10GBASE-T ad hoc report

Fast retrain and link monitoring

IEEE 802.3az

Energy Efficient Ethernet

Figure 55-27a—EEE Refresh monitor state diagram

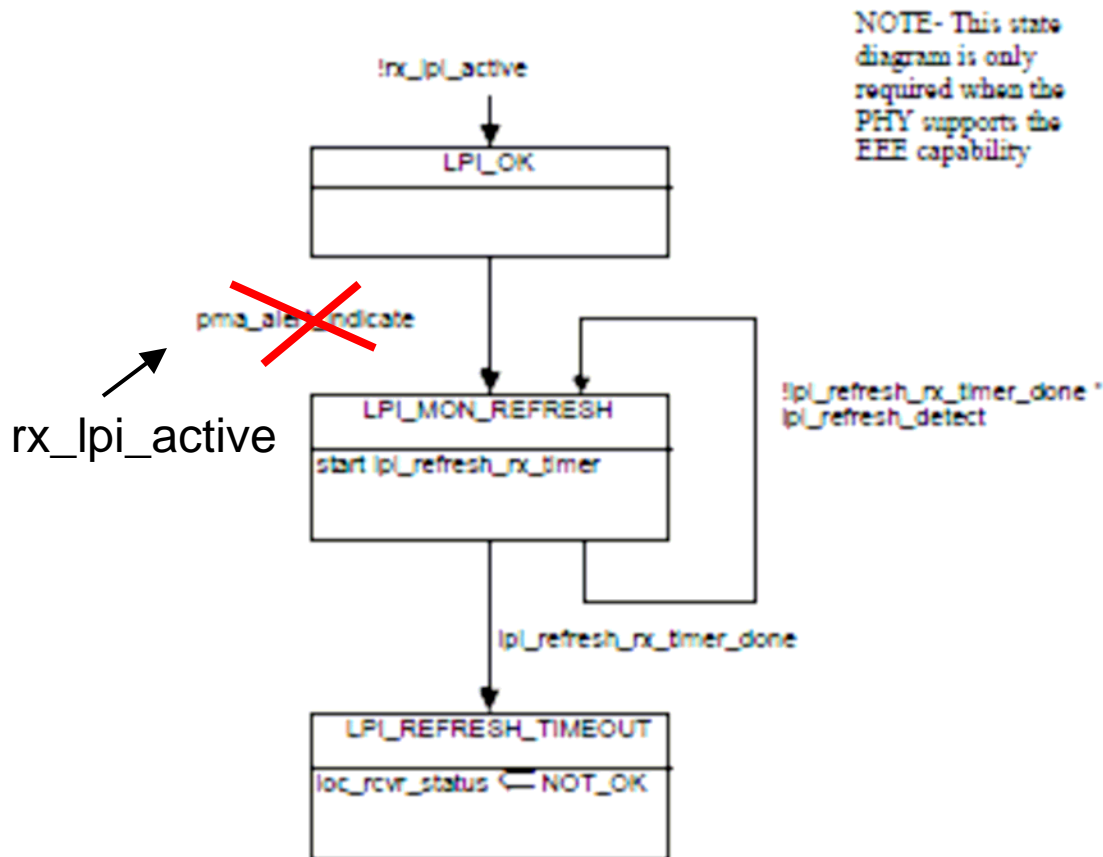
The Refresh monitor is required for PHYs which support the EEE capability. The Refresh monitor operates when the PHY is the low power receive mode. The Refresh monitor shall comply with the state diagram of Figure 55–27a. The function forces a link retrain if a refresh signal is not reliably detected within a moving time window equivalent to 50 complete quiet-refresh cycles (nominally equal to 8.192 ms), when the PHY is in the lower power receive mode.

- Forces PHY to retrain if refresh signaling is NOT detected within 8.2ms window
- Avoids zombie state during LPI
- Note cut/paste error in draft

Figure 55-27b—Fast retrain control state diagram

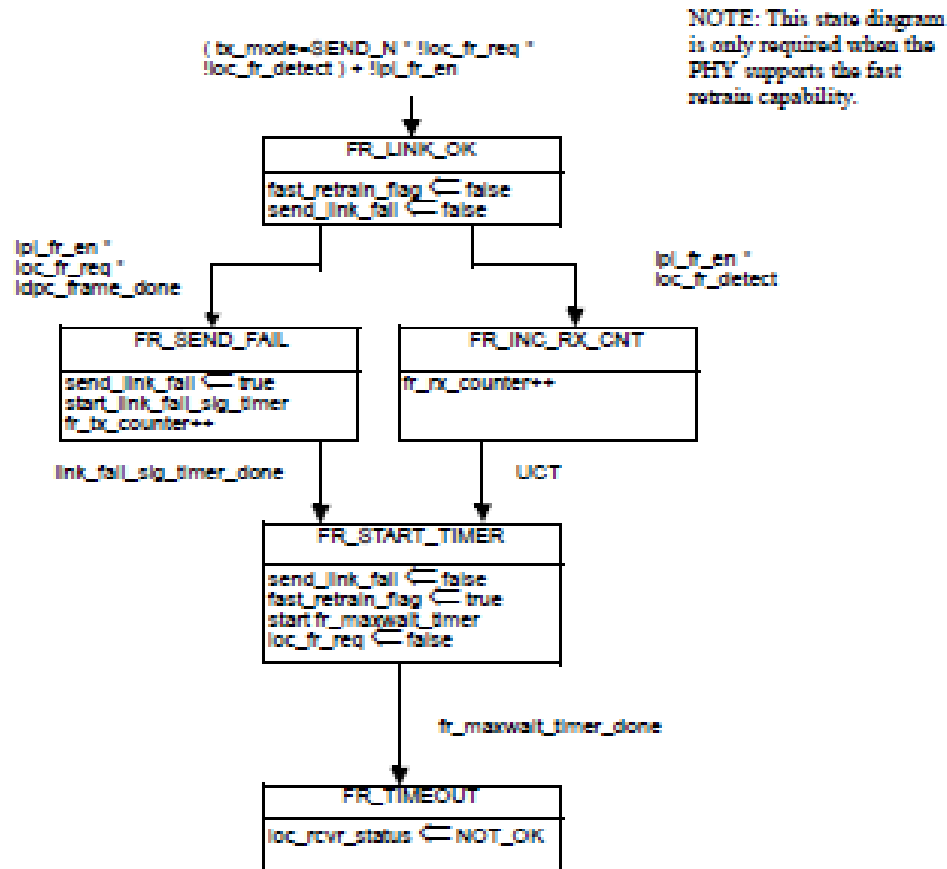
PHYs that support the fast retrain capability shall implement the fast retrain state diagram shown in Figure 55-27b. PHYs may request a fast retrain by setting the variable `loc_fr_req` to TRUE. This causes the transmission of an easily-detected link failure signal. After transmitting the link failure signal the PHY shall transition to the `PMA_Coeff_Exch` state and send PAM2 signaling within a time period equivalent to 9 LDPC frame periods after completing the link failure signal.

- PHY may request fast retrain using a special link failure signal
- The link has 30ms after the fast retrain signal to return to pcs data mode
- If the fast retrain fails the link performs a full retrain

Figure 55-24—PHY Control state diagram

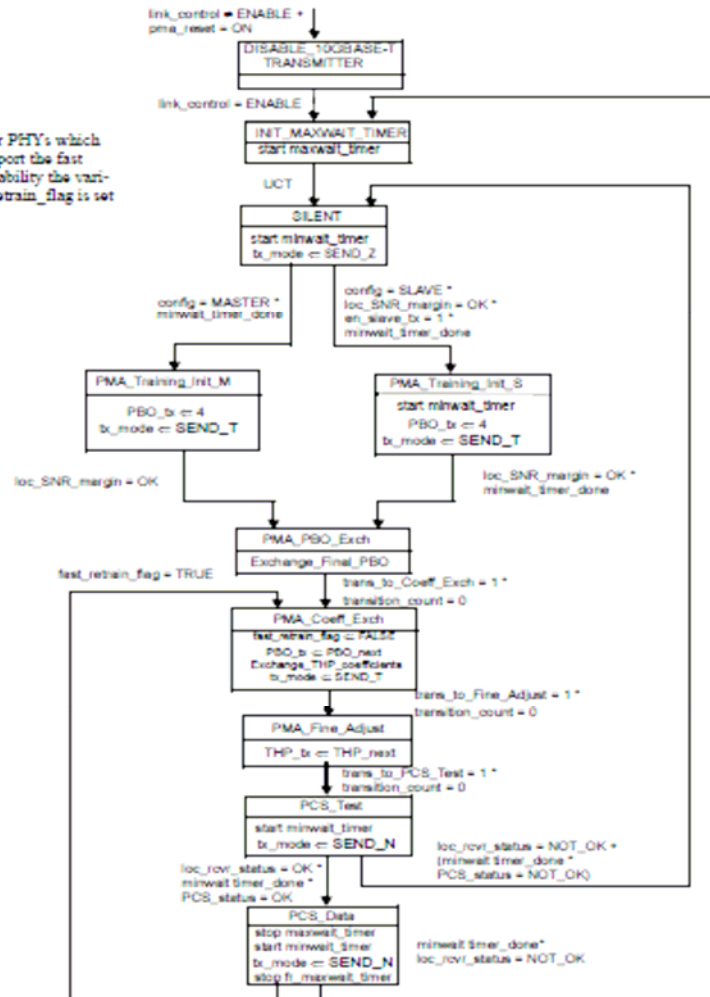
NOTE: For PHYs which do not support the fast retrain capability the variable `fast_retrain_flag` is set to FALSE

Figure 55-25—MASTER transition counter state diagram

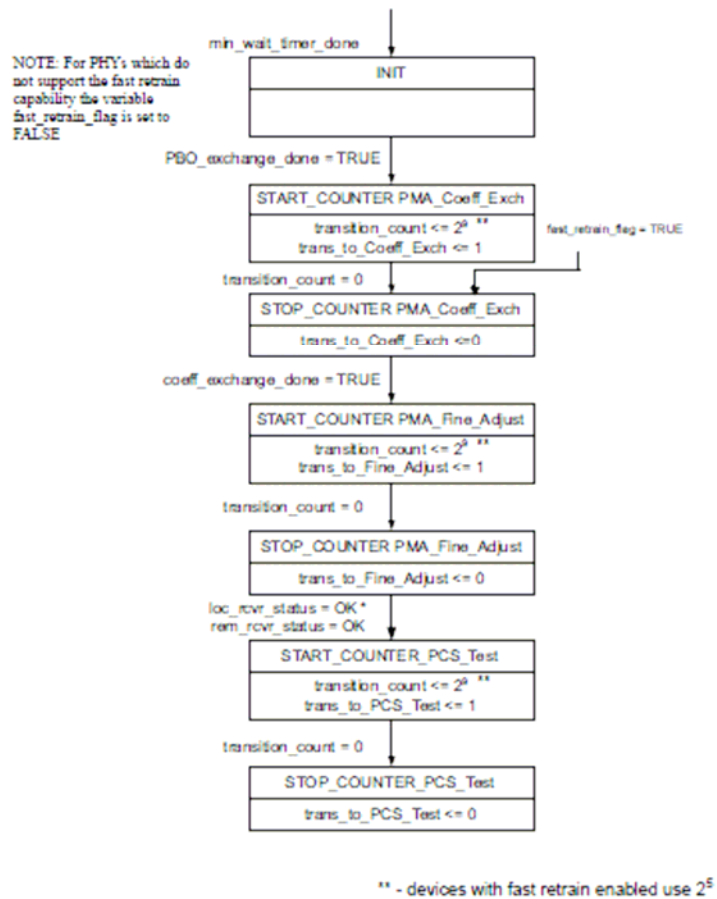
Following the link failure signal, the two link partners transition back to the `PMA_Coeff_Exch` state and follow the training procedure described in 55.4.2.5.14, with the exception that the initial infocountdown values are reduced as indicated in Figures 55-25 and 55-26.
